Item ID: D206-642-341 Accept *N900040100* Setup Start *NS1*
 Revision ID:
 Item Name: Replacement Skidtube (Fits LH or RH) Stop *NS2*
 Start Date: 8/14/2015 Start Qty: 1.00 ** Cust Item ID:
 Required Date: 8/14/2015 Req'd Qty: 1.00 ** Customer:
 Reference:

DESIGN	DS	DART AEROSPACE USA, INC	
DRAWN	AJS	PORT HADLOCK, WA	
CHECKED		DRAWING NO.	REV. F
MFG. APPR.		D2650	SHEET 2 OF 6
APPROVED		TITLE	SCALE
DE APPR.		206/407 SKIDTOE ASSEMBLIES	
DATE	08.08.08	COPYRIGHT © 1997 BY DART AEROSPACE USA, INC THIS DOCUMENT IS PRIVATE AND CONFIDENTIAL AND IS SUPPLIED ON THE EXPRESS CONDITION THAT IT IS NOT TO BE USED FOR ANY PURPOSE OR COPIED OR REPRODUCED WITHOUT THE WRITTEN PERMISSION FROM DART AEROSPACE USA, INC.

DRAWING NO. D2650	TITLE 206/407 SKIDTUBE ASSEMBLIES	REV. F	DART AEROSPACE LTD ENGINEERING ORDER		D.E.O. NO. D2650-F-1	SHEET NO. SHEET 1 OF 1	SCALE NTS
DRAWN <i>[Signature]</i>	CHECKED A.P.	MFG. APPR. <i>[Signature]</i>	APPROVED <i>[Signature]</i>		DE APPR. <i>[Signature]</i>		
DATE 12.10.12	DATE 12.10.22	DATE 12.10.22	DATE 12.10.22		DATE 12.10.22

DETAIL G

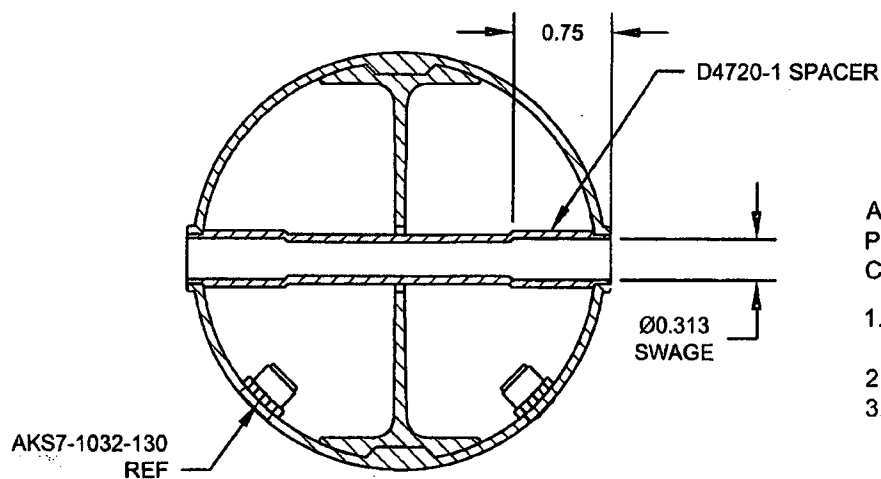
CHANGE C'BORED WELDED CROSSBOLT SPACERS TO SWAGED SPACERS

ADD DETAIL G BELOW, WHICH IS THE SAME SECTION VIEW AS DETAIL D OF DWG.
C'BORED HOLES ARE **NOW SWAGED** PER DETAIL G BELOW. FOR THE Ø0.375 HOLE THAT IS NOT C'BORED, WELD PER DETAIL D OF DWG (SEE AMENDED DETAIL B FOR REFERENCE).

AFTER DRILLING AND BENDING ASSEMBLY
PERFORM THE FOLLOWING FOR Ø0.375 HOLES THAT ARE
CURRENTLY C'BORED:

1. INSERT D4720-1 SPACER, 16 PL (-1) OR 17 PL (-3)
OR 19 PL (-5) OR 23 PL (-7)
2. SWAGE TO Ø0.313 X 0.75 DP PER QSI 002
3. TRIM / GRIND FLUSH PER QSI 002
